Notes: input buffer modification

Clee Quantizer input buffer modification

original DG408/ original unmodified circuit

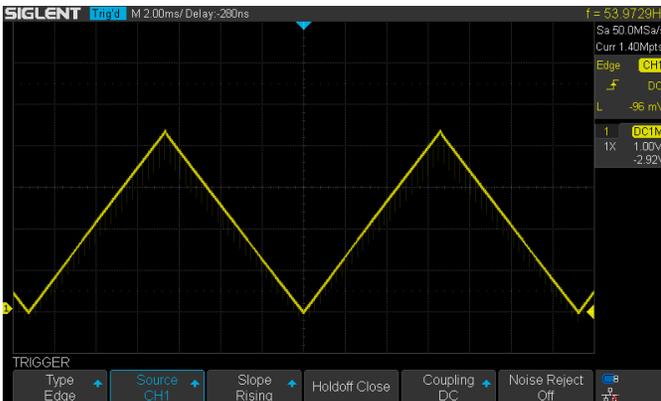
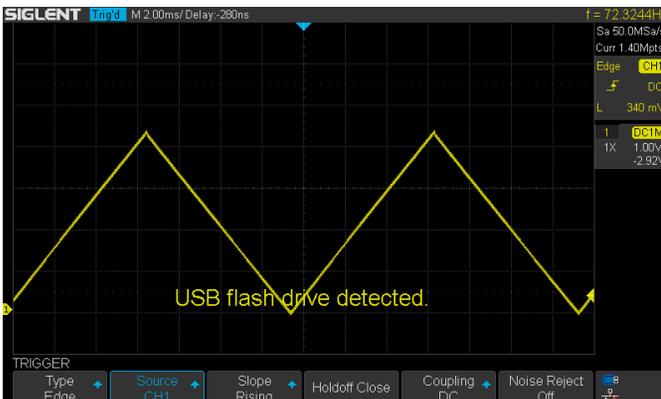
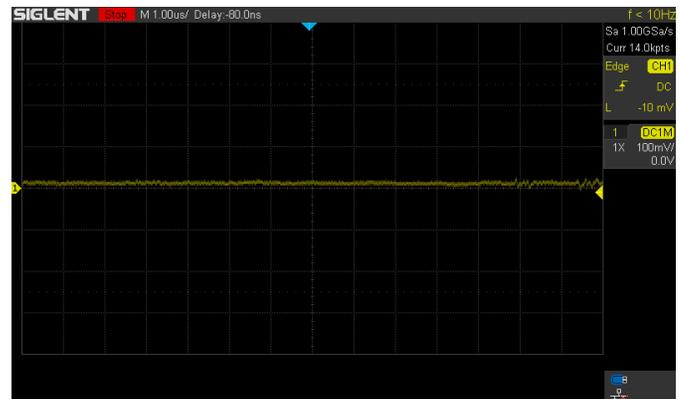
The Quantizers input multiplexer chip is adding large very short (about 0.5usec) negative going spikes to the input. They will be present on the input signal once the patch cable is plugged in. They show up because the output protection resistor of the module you're plugging in causes an output impedance between 100R-1K Ω and charge injection in the multiplexing chip causes a spike at it's FET drain which is connected to a high impedance node.

transient is aprox 1.8v

transient is aprox 0.3v

The solutions involve replacing the DG408 multiplexer chip with a DG408CJ+ chip specifically designed with a low charge injection, and/or installing input buffers on channels 1-7. Changing the chip and installing the buffer board will be the most effective solution. Channel 8 is already buffered by the attenuverting input control

replaced DG408 /original unmodified circuit

replaced DG408/ input buffers installed

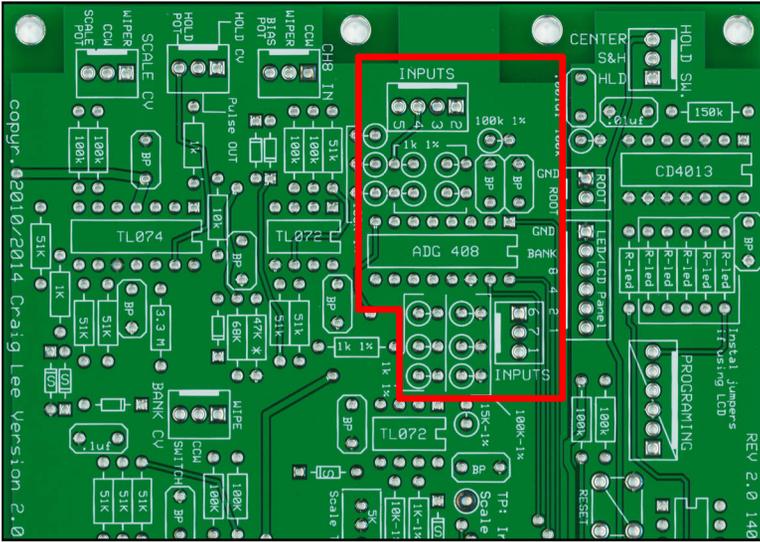
Replace this DG408 with DG408CJ+, this is the version with the lowest charge injection

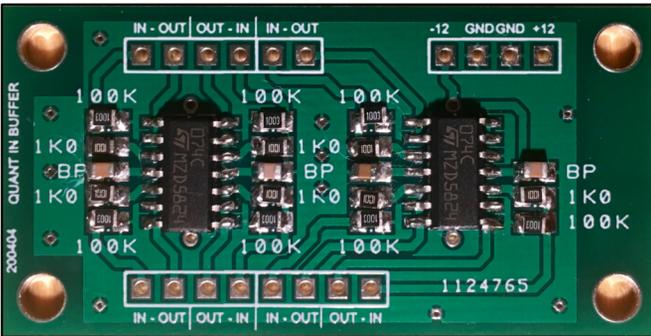
If building a new Quantizer, don't install these 100K resistors and replace the 1K0 with jumper wire

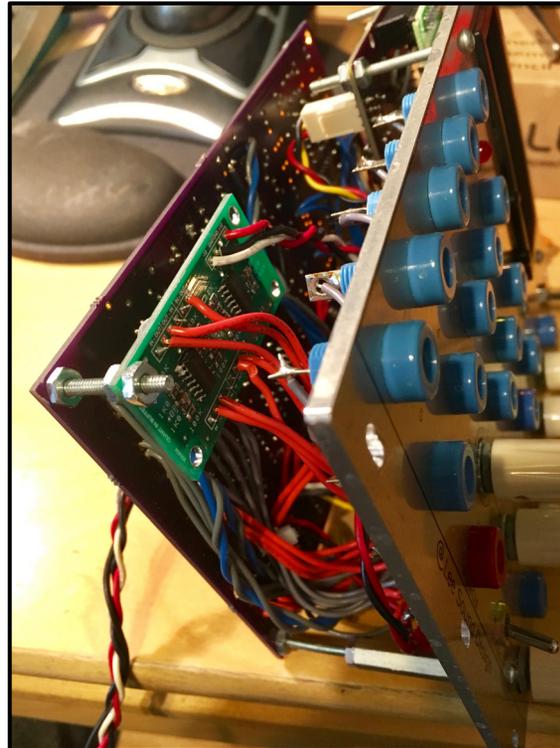
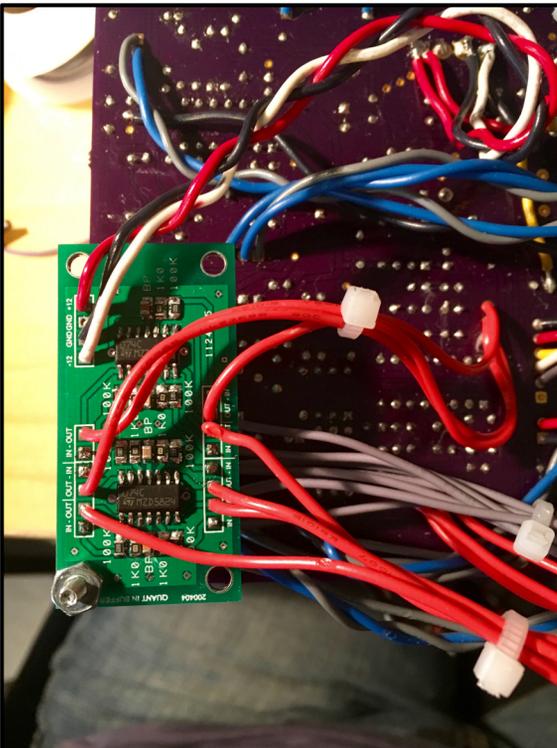
The buffer board is a small PCB with 7 unity gain buffers. Wire the connections from the panel jack to IN on the buffer board, and the buffer board OUT going to the inputs of the Quantizer PCB.

Connect inputs 1-7. Input 8 is already buffered by the processing input circuit

The red wires are the inputs to the Quantizer main board. The gray wires are from the front panel

Input buffer PCB

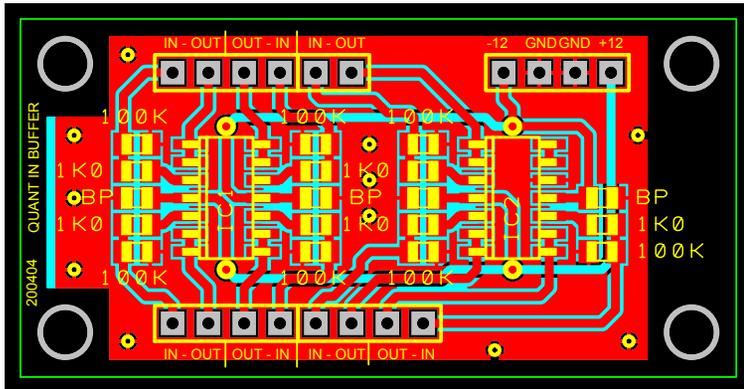
This small PCB can be mounted to one corner of the main Quantizer PCB.

The panel input jacks should be connected to the pads marked IN, and the OUT pads should be connected to the Quantizer main PCB inputs

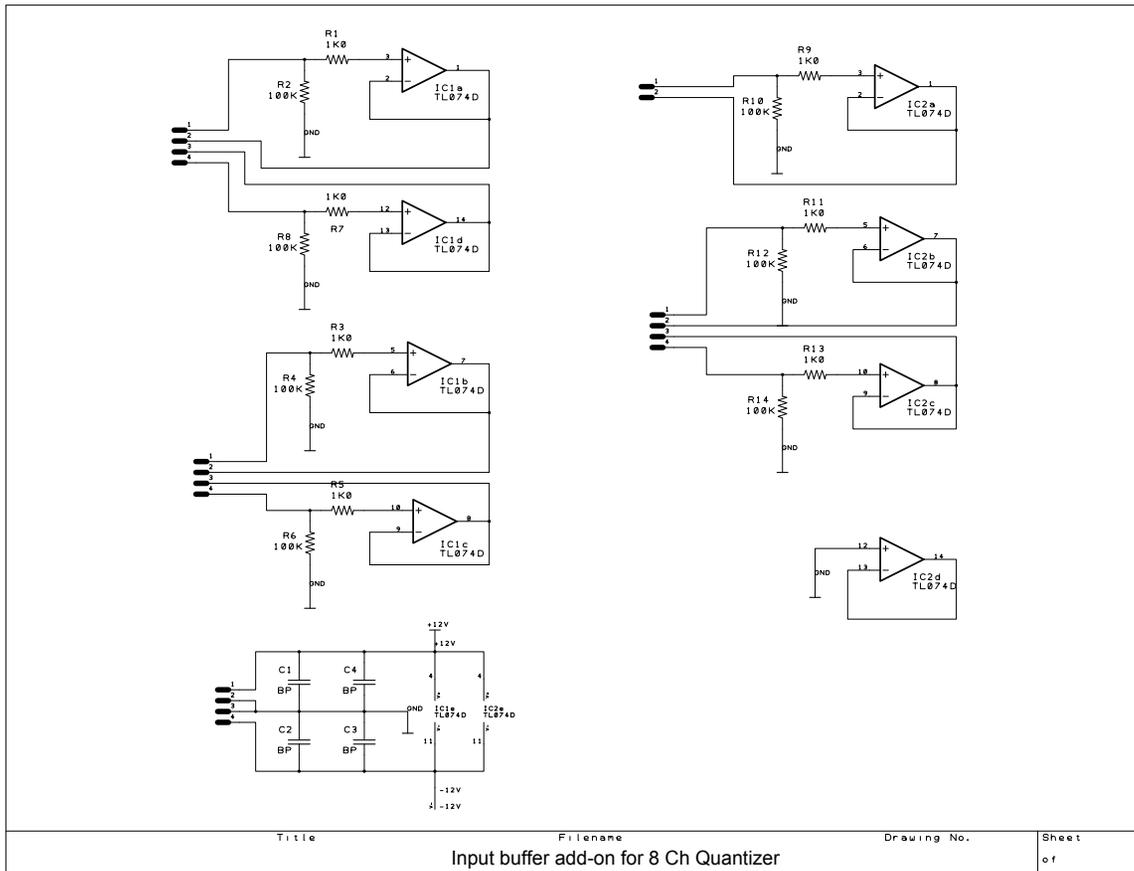
If you have a board without PIN 1 designated, PIN 1 is UP in this picture.
